## STAFF REPORT

Community Planning and Preservation Commission  
Certificate of Appropriateness Request

Case No.:	19-90200041
Address:	600 4 <sup>th</sup> Street South
Legal Description:	U.S.F. SECOND REPLAT BLK 1, LOT 2 & PART OF LOT 1 ALL DESC AS BEG NE COR OF LOT 2 TH S00D36'15"E 195FT TH S89D26'04"W 175FT TH S00D36'15"E 15FT TH N89D26'04"E 175FT TH N00D36'15"W 50FT TH N89D26'04"E 100FT TH S00D36'15"E 40FT TH N89D26'04"E 65FT TH N00D36'15"W 200FT TH N89D26'04"E 185FT TO POB
Parcel ID No.:	19-31-17-93339-001-0020
Date of Construction:	1925
Local Landmark:	Studebaker Building (HPC 86-12)
Owner:	FL INT IMP FUND TRE C/O DEPT NATURAL RESOURCES
Agent:	Lorraine Armstrong
Request:	COA for replacement of historic steel windows at second level

Proposed  
EXAMPLE  
↓  
TYPE A

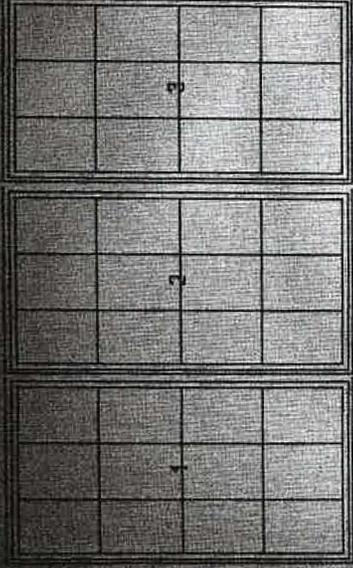
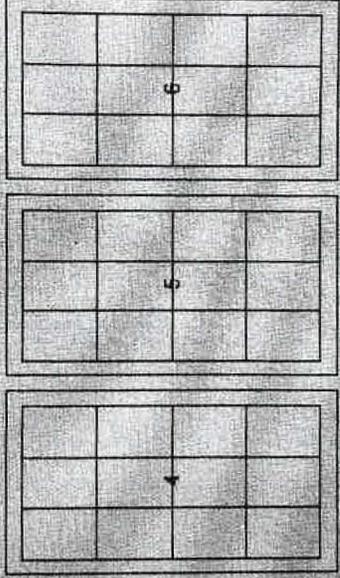
The proposed changes would remove the unique pivot functionality featured in the existing historic windows and replace their industrial hardware with fixed windows. The lite division is proposed to be replicated with a slight increase in width of exterior frames and thickness of muntins.

The proposal generally replicates existing muntins.
